Civil Air Regulations Amendment 3-5

**PART 3—AIRPLANE AIRWORTHINESS;  
NORMAL, UTILITY, AND ACROBATIC CATEGORIES**

**Miscellaneous Amendments Resulting  
From the 1958 Annual Airworthiness Review**

FIGURE 3-13.—CONTROL KNOB SHAPES.

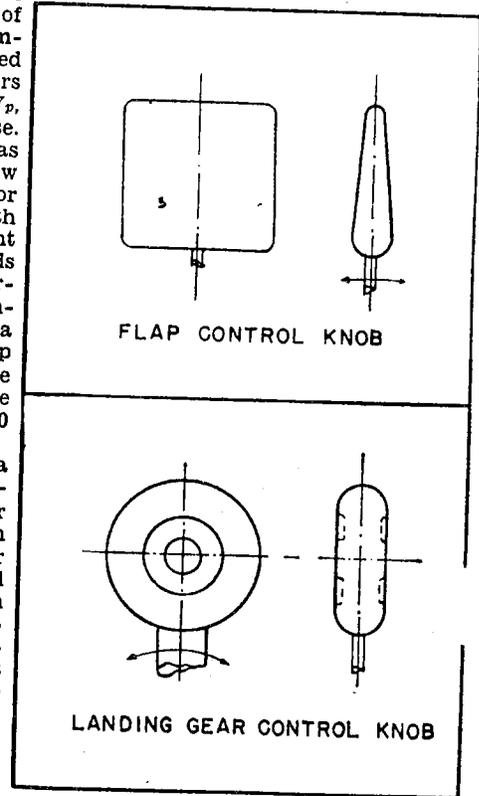
(3) The control knobs shall be shaped in accordance with figure 3-13.

NOTE: Figure 3-13 is not intended to indicate the exact size or proportion of the control knobs.

9. By adding a new figure 3-13 as follows:

(c) The wing flap and landing gear controls shall comply with the following:

(1) The wing flap or auxiliary lift device control shall be located centrally or to the right of the pedestal centerline or of the powerplant throttle control centerline and shall be sufficiently displaced

from the landing gear control to avoid confusion.

(2) The landing gear control shall be located to the left of the throttle centerline or of the pedestal centerline.
